24 May 2021

## **Re. Urban Resign Commentary in regard to the Planning Proposal for No. 3 Ellis Street, Chatswood.**

**Building envelope: Revised Option No. 1 scheme (May 2021)**

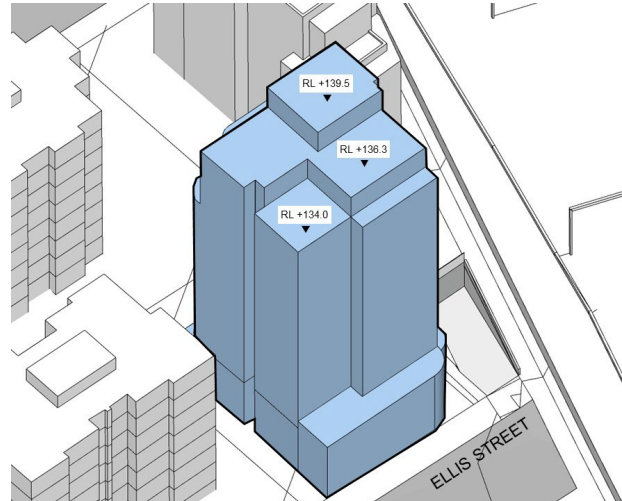
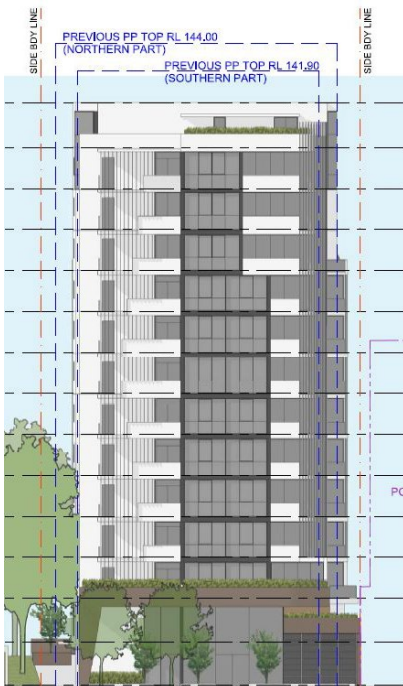
The increased setback to the west allows the predominant part of the upper building alignment to remain below the Sun Access Protection Plane (and the Pans Ops plane), as indicated in the elevational studies (Ellis Street) prepared by MGA Architects P/L below.

**Zone of reduced bulk and scale**

Aside from reduced overshadowing impact, the proposed reduction in building height along the western part of the subject site creates variation and visual interest to the building profile as presented to the public domain. It also creates slender proportions to accentuates the verticality of the built form at the south eastern corner of the site.
